ADDENDUM NUMBER 1

GENERAL MITCHELL INTERNATIONAL AIRPORT  
GROUND TRANSPORTATION PARKING LOT RESTROOM  
Site #290, VFA Bldg. #340, GMIA Bldg. #1-53  
5300 South Howell Avenue  
Milwaukee, Wisconsin 53207

Project Number: A206-16011-02

Date of Addendum: July 29, 2016

**BDA-001**

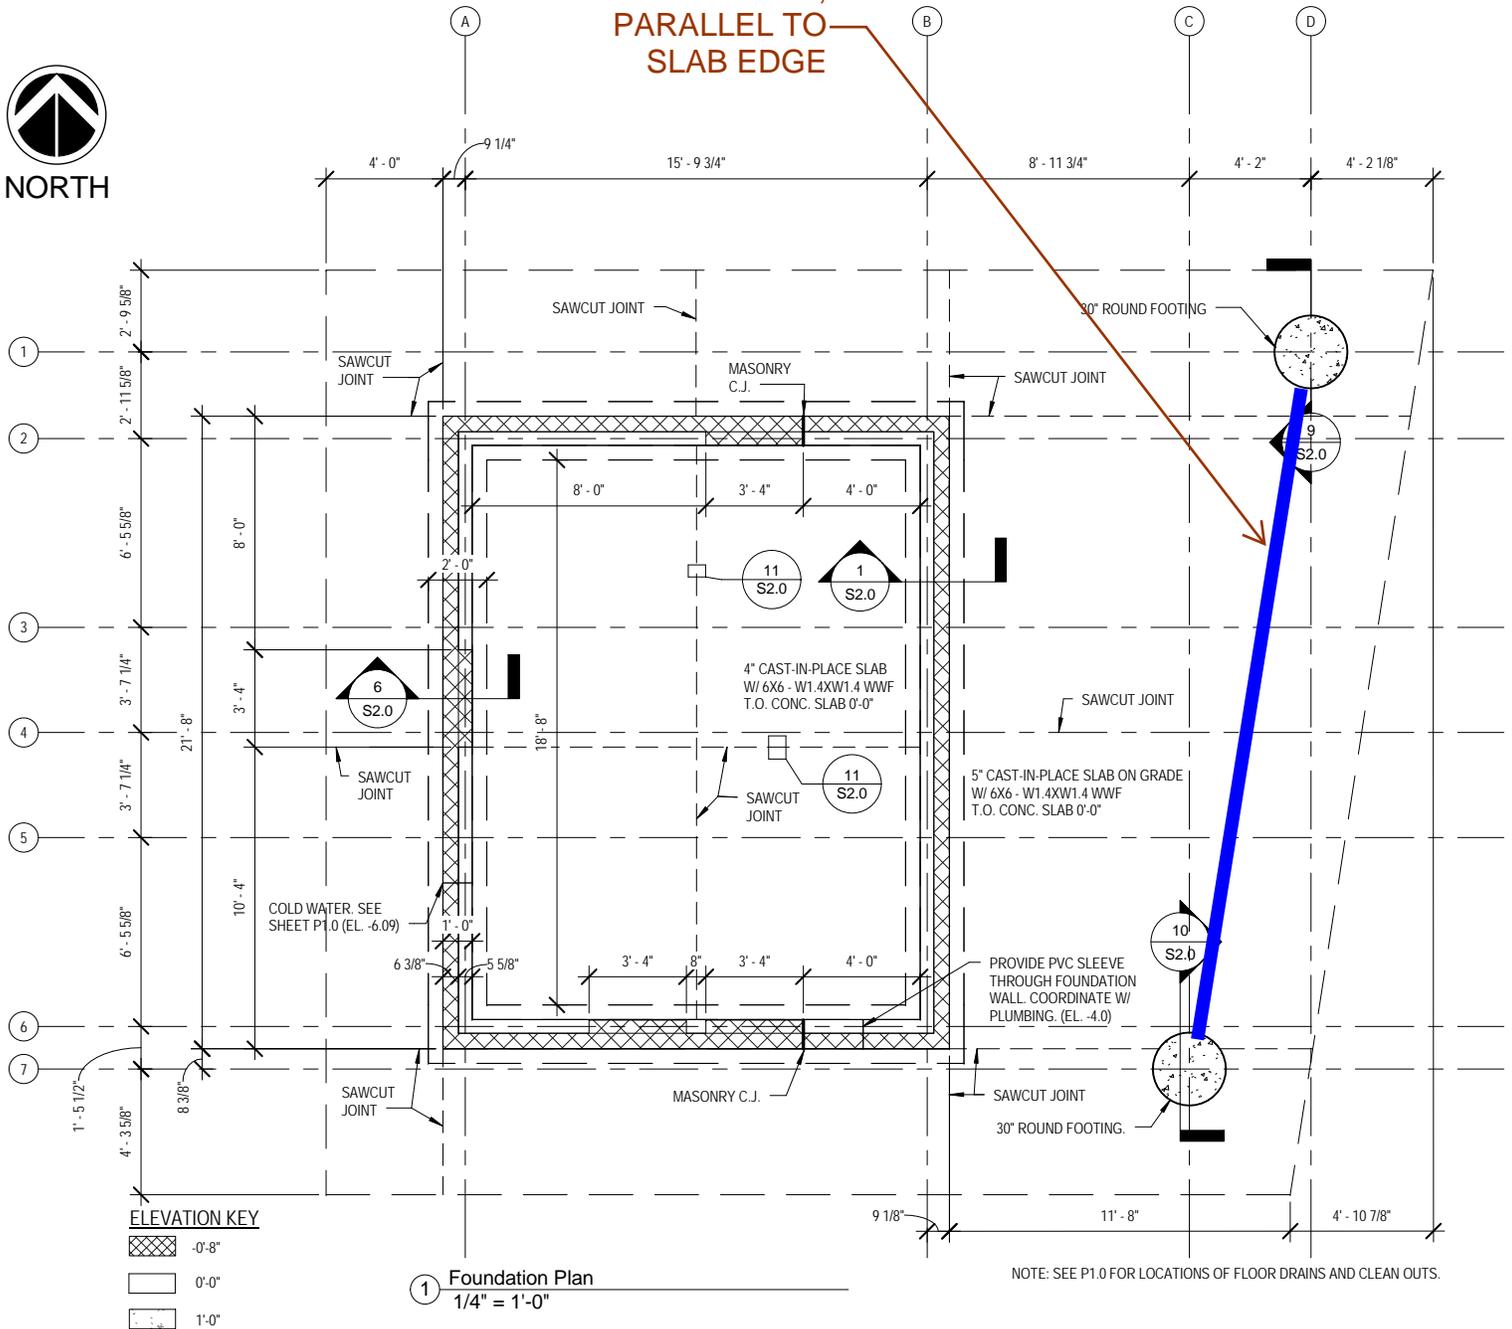
- Q. Added one additional concrete saw cut.
  - a. See BDA-001
- R. Revised Door Schedule and added Hardware groups to Spec.
  - a. See BDA-006
- S. Added 5/C5.1 – Sanitary Sewer Interior Drop Detail. Note: Location of manhole steps will need to be confirmed in order to properly place the interior drop
  - a. See BDA-007

SAW CUT JOINT,  
PARALLEL TO  
SLAB EDGE

Title	REVISED 1/S1.0 - ADD SAW CUT
Project	GMIA - GROUND TRANSPORTATION LOT AND RESTROOM
Project Number	A206-16011-02 (UWA# 16-110)
Date	JULY 29th, 2016
Drawn by	UWA

**BDA-002**

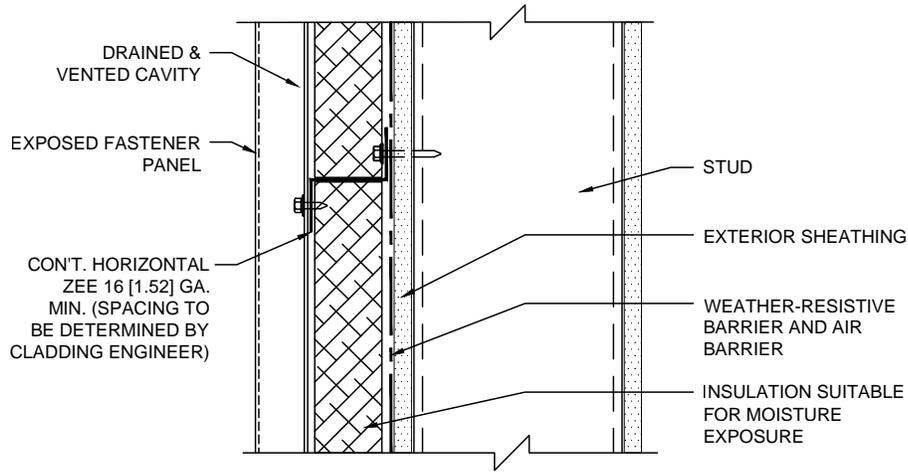
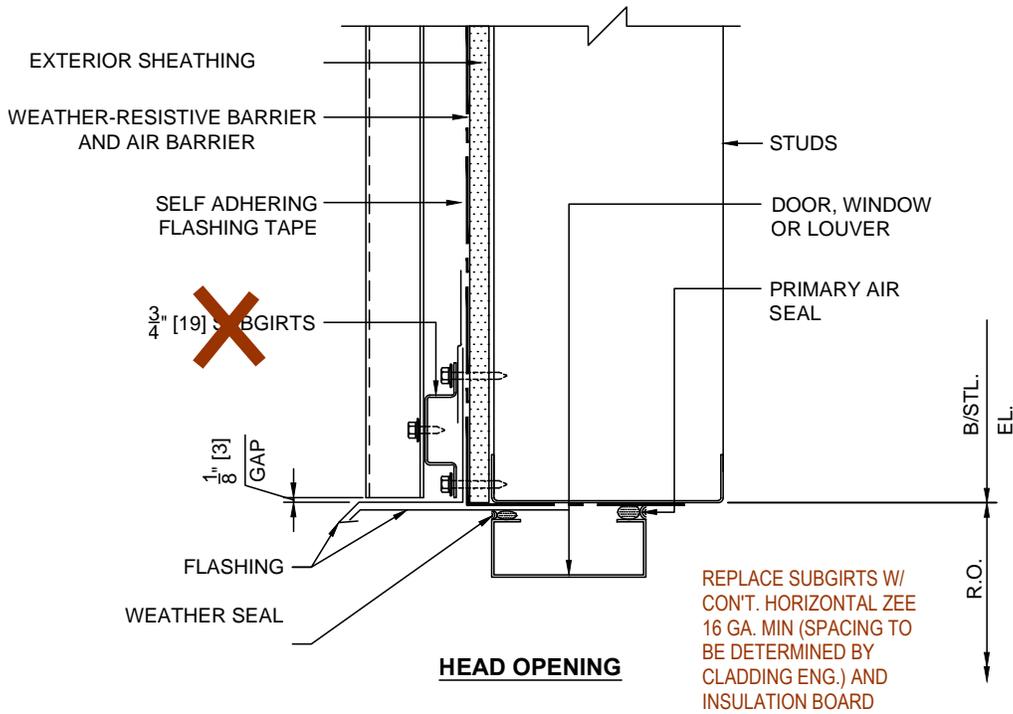
- A. 3/A1.0 – Paint all exposed steel structure
- B. 3/A1.0 – “MR” = Moisture Resistant
- C. Note (D) on A7.0 – Thickness to be ADA compliant
- D. Attached generic product installation details for metal panel, reference for design intent.

- a. See BDA-002 through BDA-005
- E. 3/A5.0 – No additional wall construction above CMU between Utility and Restrooms.
- F. Electrical Hand Dryer by GC. Xlerator: Model XL-SB, Brushed Stainless Steel.

REPLACE SUBGIRTS W/  
 CONT. HORIZONTAL ZEE  
 16 GA. MIN (SPACING TO  
 BE DETERMINED BY  
 CLADDING ENG.) AND  
 INSULATION BOARD

**BDA-003**

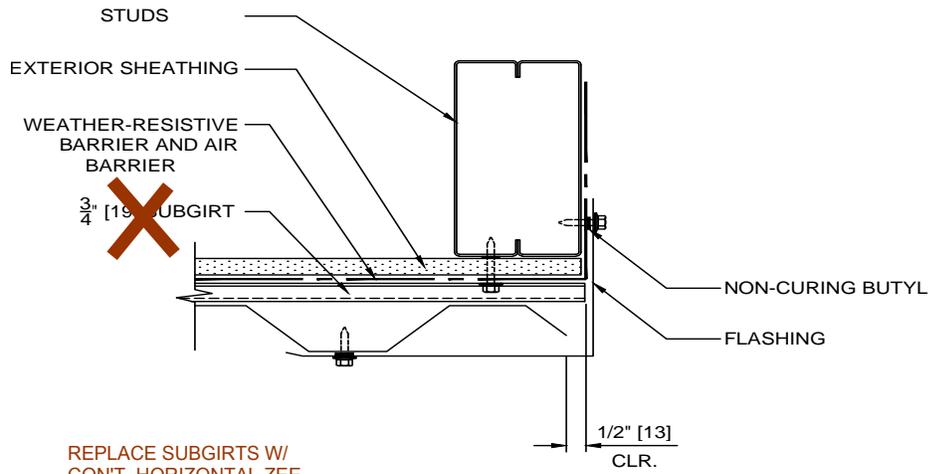
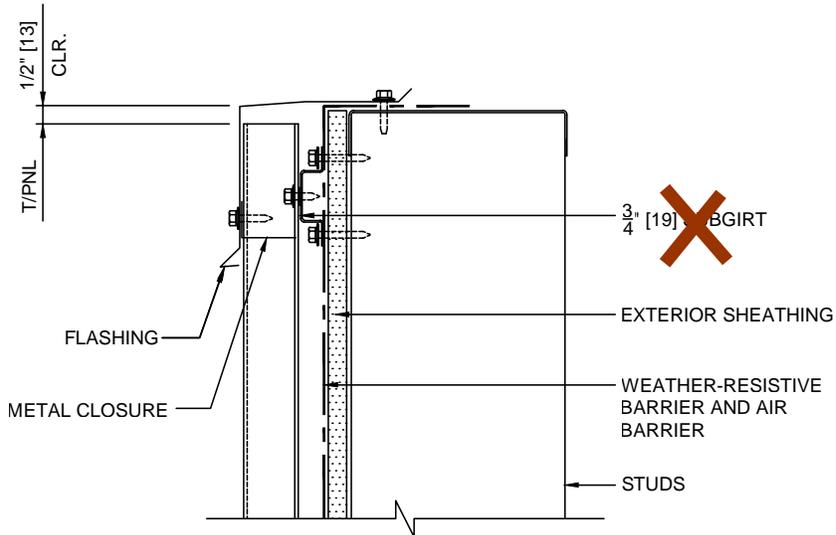
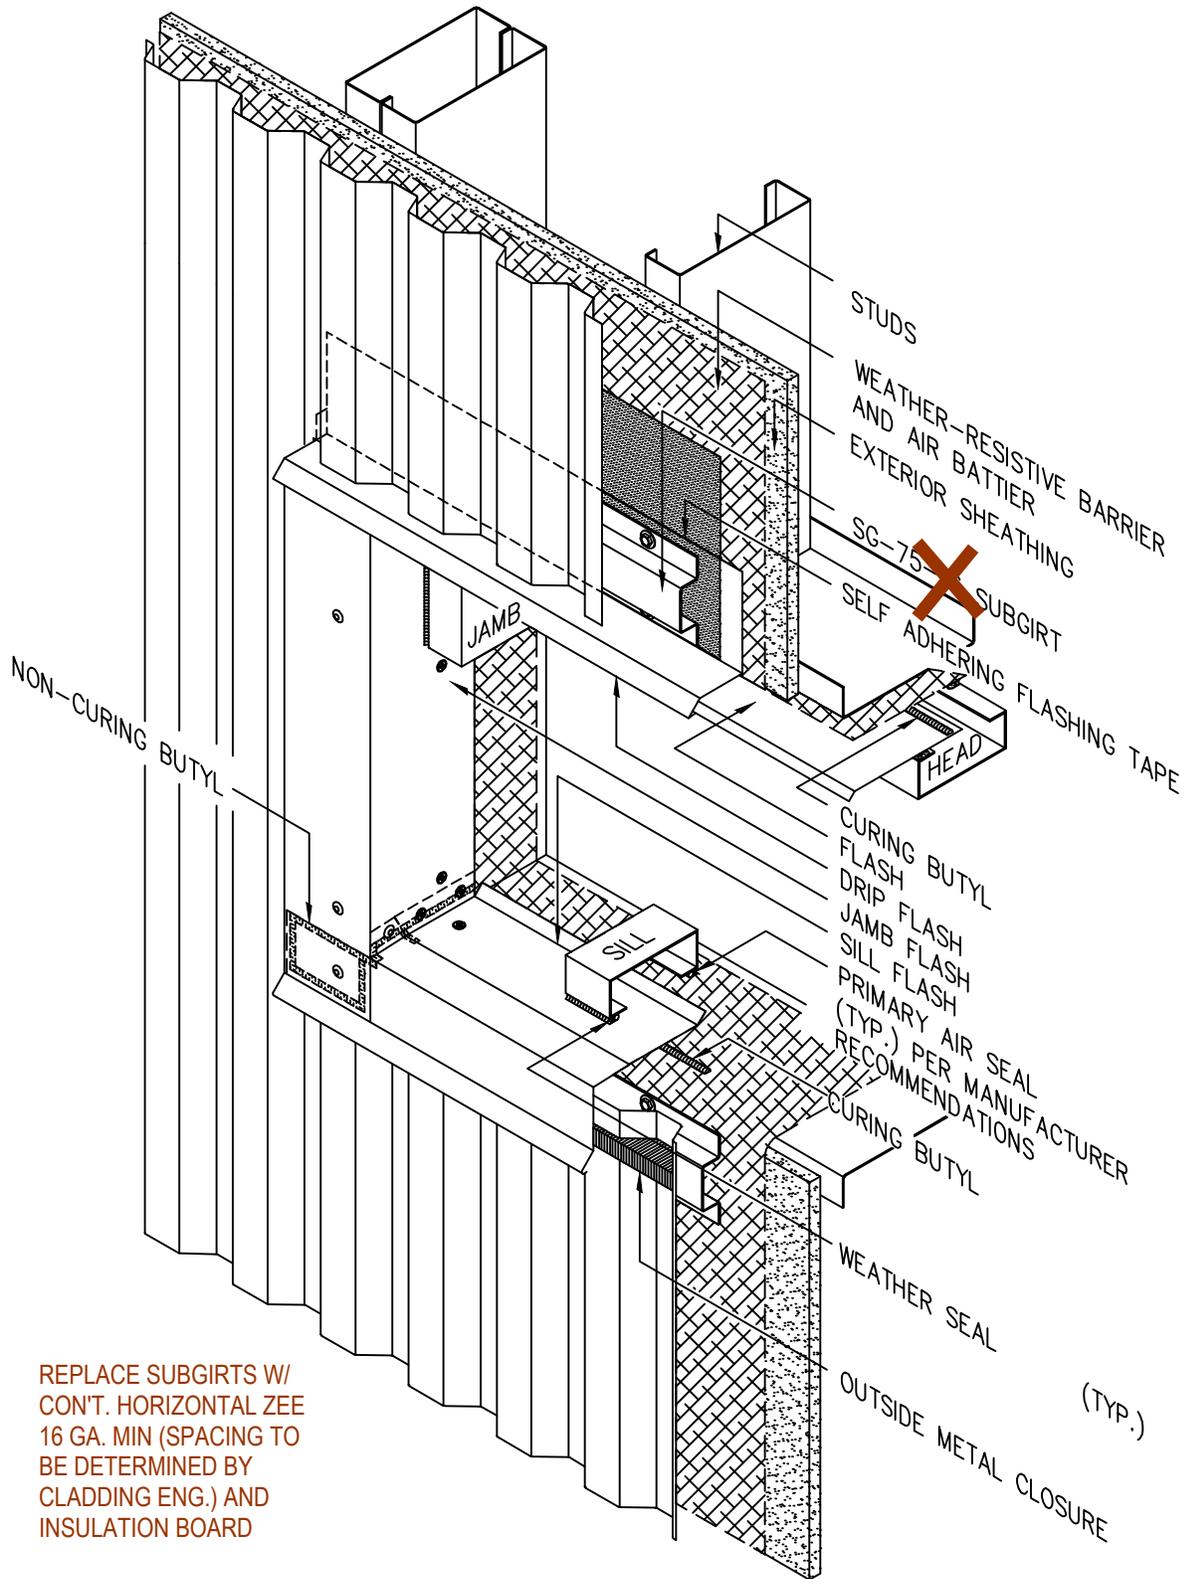
REPLACE SUBGIRTS W/  
 CONT. HORIZONTAL ZEE  
 16 GA. MIN (SPACING TO  
 BE DETERMINED BY  
 CLADDING ENG.) AND  
 INSULATION BOARD

REPLACE SUBGIRTS W/  
 CONT. HORIZONTAL ZEE  
 16 GA. MIN (SPACING TO  
 BE DETERMINED BY  
 CLADDING ENG.) AND  
 INSULATION BOARD

**BDA-005**

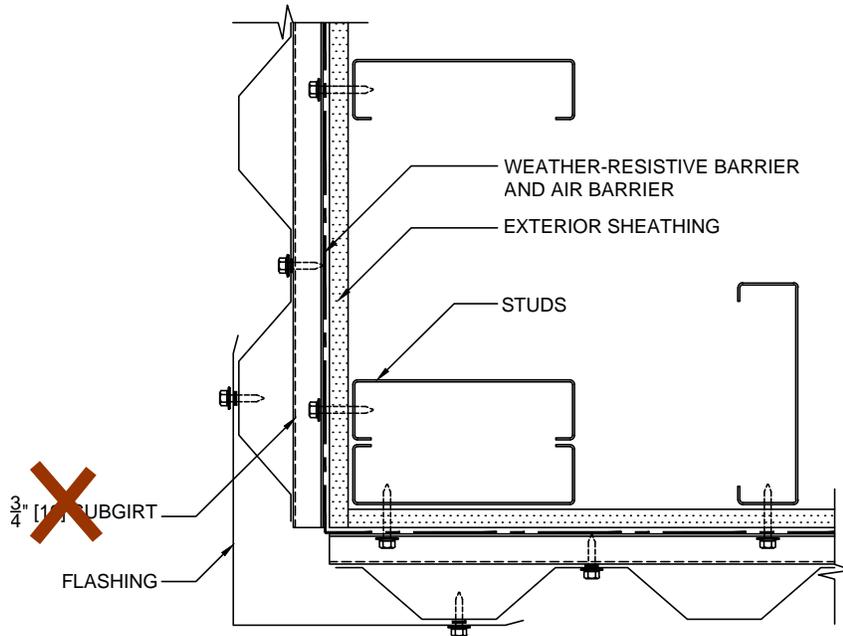
REPLACE SUBGIRTS W/  
 CONT. HORIZONTAL ZEE  
 16 GA. MIN (SPACING TO  
 BE DETERMINED BY  
 CLADDING ENG.) AND  
 INSULATION BOARD
